Notice of Decision

Water Pollution Control Permit
Number NEV0089068

Barrick Goldstrike Mines, Inc.

Boulder Valley Infiltration Project

Figure 1. Arsenic Concentration of Excess Mine Water after Treatment (CCE)

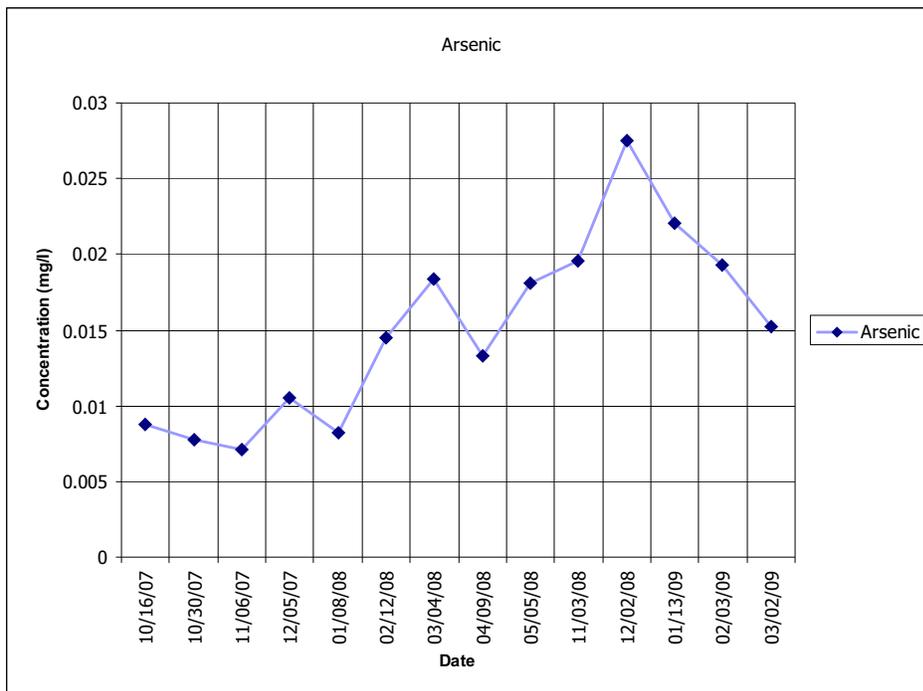
Comment 3: “The 2008 Annual Report shows a significant increase in arsenic concentration in the feed water (GFPD-02A). However, the annual report does not include graphs for treated water, so it is not known if this represents the quality of water being discharged to the groundwater; it is also not known whether the treatment plants have been operated. The permit requires the annual report to include only information from items I.D.1 through I.D.5, not I.D.6 which would be treated water. Based on the footnote for I.D.6, the “ferric sulfate treatment water treatment plant is operated as needed for arsenic reduction in the non-irrigation season” (Draft permit, page 3). How does Barrick determine whether treatment is necessary? How does NDEP verify whether treatment is being used when necessary? It appears that Barrick did not treat the water referred to in the previous paragraph because there is no evidence that the monitoring wells were sampled monthly as required when the treatment plant is operating, according to the referenced footnote. Is this correct?”

Response: Since 2007, when the inflow of treated Leeville water was reduced, excess mine water has been treated at the Ferric Sulfate Treatment Plant prior to infiltration into the groundwater system through the TS Ranch Reservoir. The feed water is sampled as “GFPD-02A”, and discharge water is sampled as “CCE”. Figure 1 indicates that the arsenic concentration of “CCE” is below the Profile I reference value (50 ppb). The data have been included in the permit reports.

Figure 2. Hydrographs of Piezometers Near the TS Reservoir.

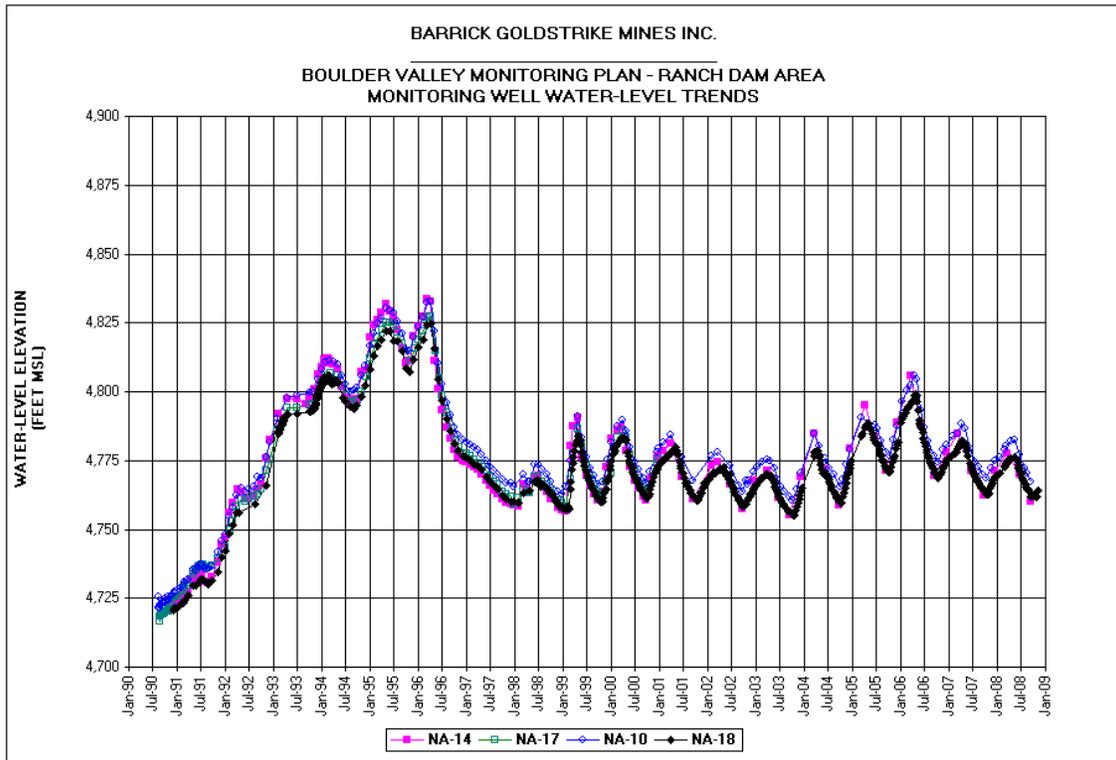
Comment 4: “The annual report does not show that any of the monitoring wells have been affected by the arsenic being discharged to the alluvium, but the location of the monitoring wells is not opportune for monitoring water quality from discharge to the infiltration basins. Only NA-22 is nearby, and it does not appear to be downgradient from the basin (although at the scale of the map, it is difficult to determine). NA-10 and NA-18 are east of the TS Ranch Reservoir, at least 2.5 miles from the basin; these are not downgradient from the reservoir either (although the mounding may have locally changed the direction of the gradient). IMW-93-2 is about one mile southwest of the basin. The other monitoring wells are even further away.

The monitoring well locations could have been selected better. Two of them, IMV93-3 and NA-32, are close enough to the irrigation pivots to be sampling the effects of irrigation return flow rather than the infiltration basins. NDEP should reconsider whether a few more shallow monitoring wells and piezometers should be installed near the basins so that the sampling is of the discharge water and any leaching that could be occurring?”

Response: *The Division is satisfied that the groundwater monitoring network was properly designed to monitor groundwater quality near the infiltration facilities. For example, NA-22 is immediately adjacent to the infiltration ponds, which receive canal water. NA-10 is about 0.7 miles away (not > 2.5 miles as stated in the review) from the TS reservoir, which receives excess mine water. The volcanic rock aquifer in the TS Reservoir area is quite permeable (about 100 ft/day). Figure 2 illustrates water levels recorded at several volcanic aquifer piezometers near the TS Reservoir. Among these piezometers, NA-10 and NA-18 are included in the permit, and NA-14 (not included in the permit) is at the downstream edge of the TS Reservoir. These wells have virtually identical responses to the infiltration.*
